**FPL Energy**  
**Seabrook Station**

**Supplemental Response to Request for Additional Information (RAI Nos. 2 and 3) Regarding  
License Amendment Request 04-03, Application for Stretch Power Uprate**

**Enclosure to Letter No. SBK-L-04116**  
**Supplemental Response To Request for Additional Information**  
**(RAI Nos. 2 and 3)**  
**for**  
**LAR 04-03, Application for Stretch Power Uprate**

Figure RAI 2-1

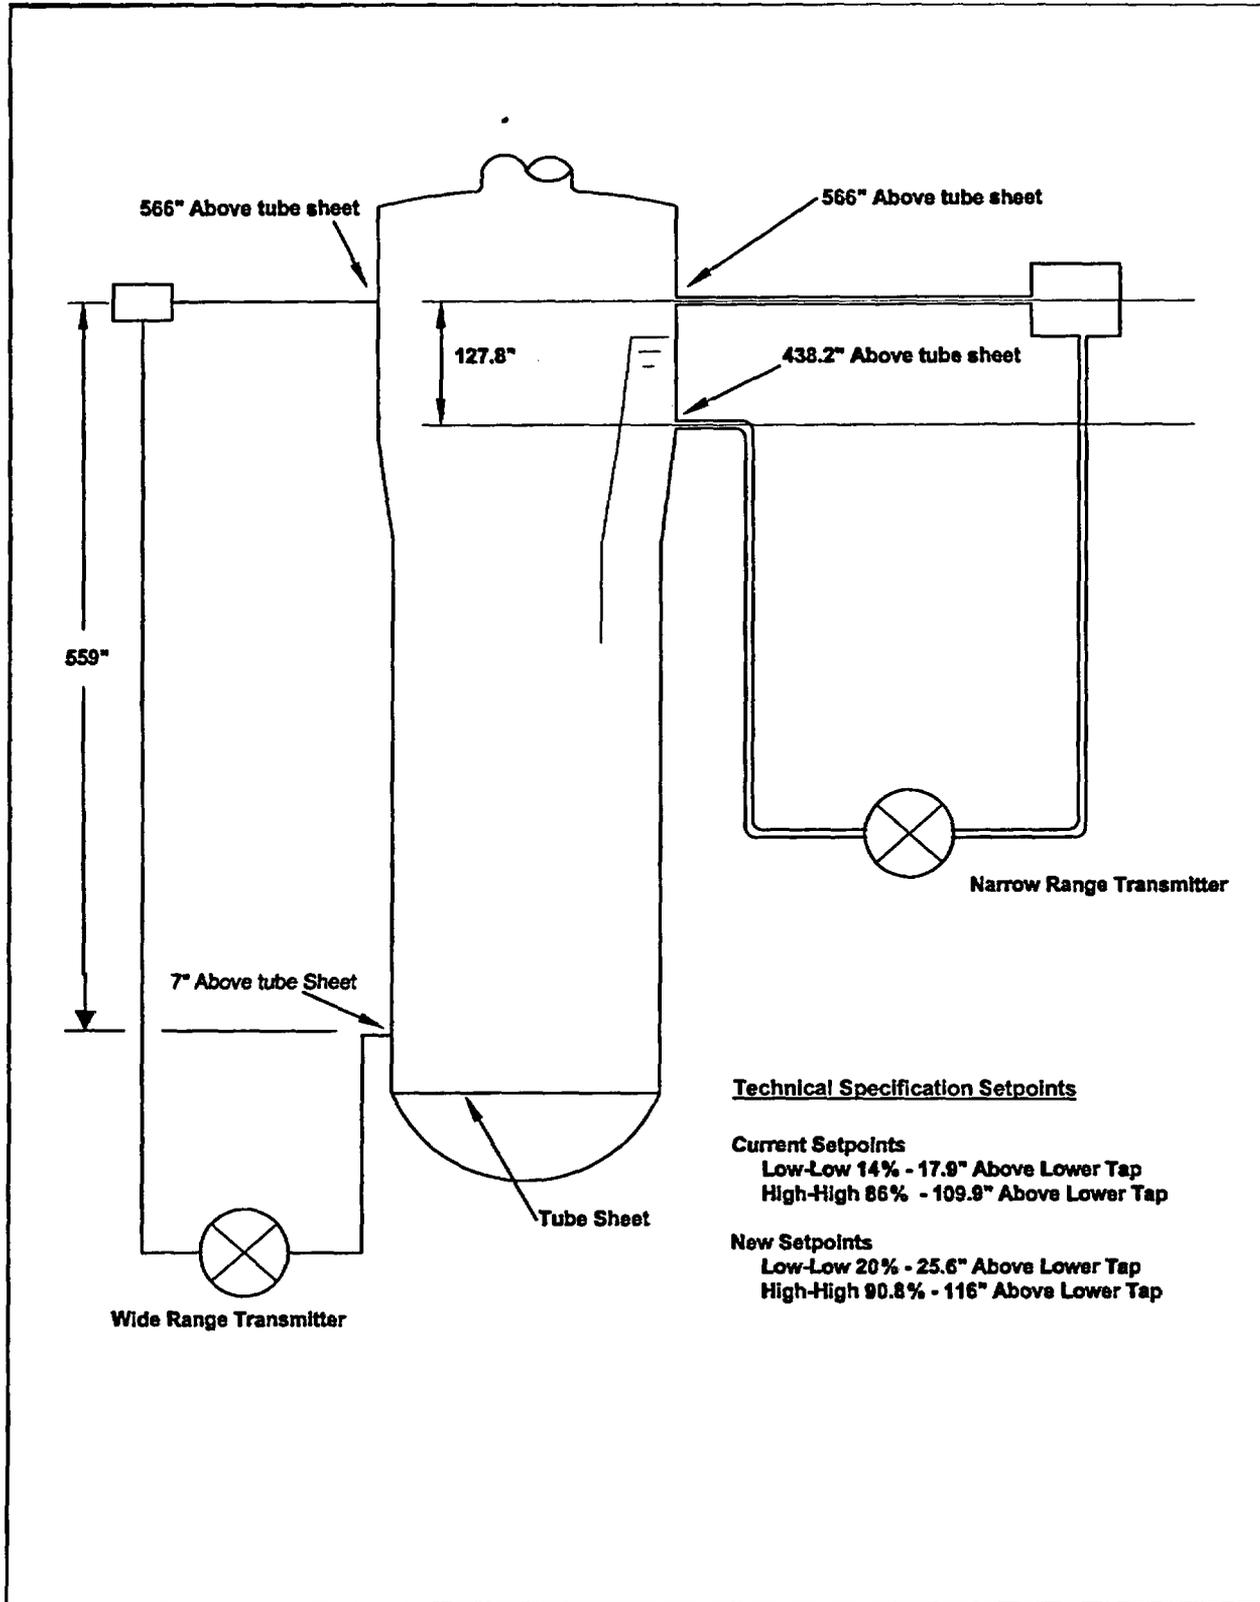
In each case where a setpoint is shown as a percentage of instrument span, identify the instrument by manufacturer, model and range, its span, and the actual and allowable physical values of the setpoint.

The response below supercedes the response to RAI #2 transmitted by FPL Energy Seabrook letter SBK-L-04072 dated October 12, 2004. This response is being revised to include information that addresses the span of the steam generator high-high instrumentation. The attachments to this response (Attachments RAI 2-1 and RAI 2-2) are not changed and are not being resubmitted.

For steam generator level, the transmitters are Rosemount model 1154DP4RA and the process racks are Westinghouse 7300 racks. The narrow range span is defined as the distance between the lower instrument tap and the upper instrument tap. The distance is 127.8 inches – see Figure RAI 2-1. The transmitter range is 150 inches of water column (W.C.) and the calibrated span is 85.72 inches of water column. The process rack range and span is 0 – 10 volts D.C. The physical unit of measure for this function is level. Based on the tap to tap distance of 127.8 inches, the previous Technical Specification low level setpoint of 14% narrow range span is 17.9 inches above the lower tap and the previous Technical Specification high level setpoint of 86% narrow range span is 109.9 inches above the lower tap. The setpoint change for the SPU is 20% of narrow range span which is 25.6 inches above the lower tap and the high level setpoint change is 90.8 % of narrow range span which is 116 inches above the lower tap.
